Access Compliance Report

Public Rights-of-Way

(Curb Ramps)

Intersection ID: 26796	Main Street: CREEK_BEND_DR	Cross Street: RUSSET_OAK_LN	Location: S
ADA ID: FEBFC9DBBD26	Ramp Type: PerpDiag	Initial Pass/Fail: Fail	Overall Compliance: No
Severity Score: 17.5			
Codes/Mitigation Info/Possible Solution		Field Measurements/Component Compliance

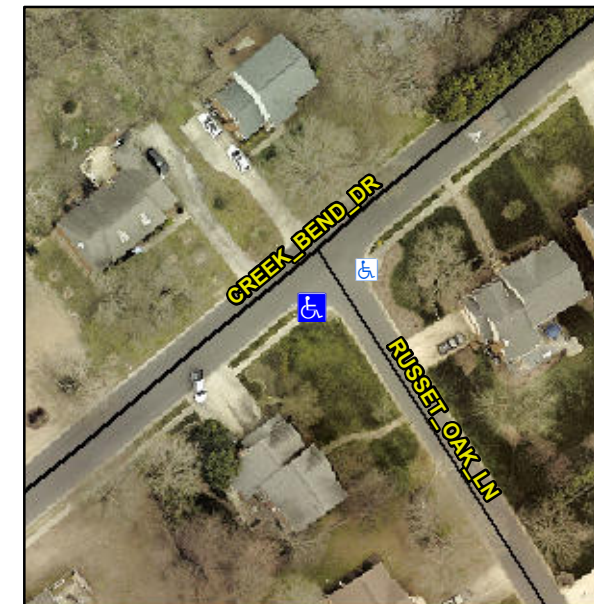
Not Found, R304.5.1

Compliance	Description	Data	Compliance	Description	Data
N/A	Ramp Length (in)	86.0	Yes	Ramp Slope (%)	6.8
No	Ramp Width (in)	32.0	Yes	Ramp XSlope (%)	0.9
N/A	Flare Type LT	N/A	N/A	Flare Type RT	N/A
N/A	Flare Slope LT (%)	N/A	N/A	Flare Slope RT (%)	N/A
N/A	Flare Traversable LT?	N/A	N/A	Flare Traversable RT?	N/A
N/A	Landing Length (in)	N/A	N/A	DWS Provided?	N/A
N/A	Landing Width (in)	N/A	N/A	DWS Contrast?	N/A
N/A	Landing Slope (%)	N/A	N/A	DWS Length (in)	N/A
N/A	Landing X Slope (%)	N/A	N/A	DWS Full Width?	N/A
N/A	Landing Curb? (Y/N)	N/A	N/A	DWS Offset (in)	N/A
N/A	Shared Landing?	N/A			
N/A	Gutter Ponding?	N/A	N/A	Gutter Slope (%)	N/A
N/A	Gutter Lip Ht (in)	N/A	N/A	Gutter X Slope (%)	N/A
N/A	Painted X Walk1?	No	N/A	Painted X Walk2?	No
	X Walk 1 Direction	To E		X Walk 2 Direction	To N
N/A	X Walk 1 Width (in)	N/A	N/A	X Walk 2 Width (in)	N/A
	X Walk 1 Slope (%)	2.1		X Walk 2 Slope (%)	0.8
	X Walk 1 X Slope (%)	0.2		X Walk 2 X Slope (%)	0.9

Remove & Replace Curb Ramp With Two New Directional Ramps or Equivalent.
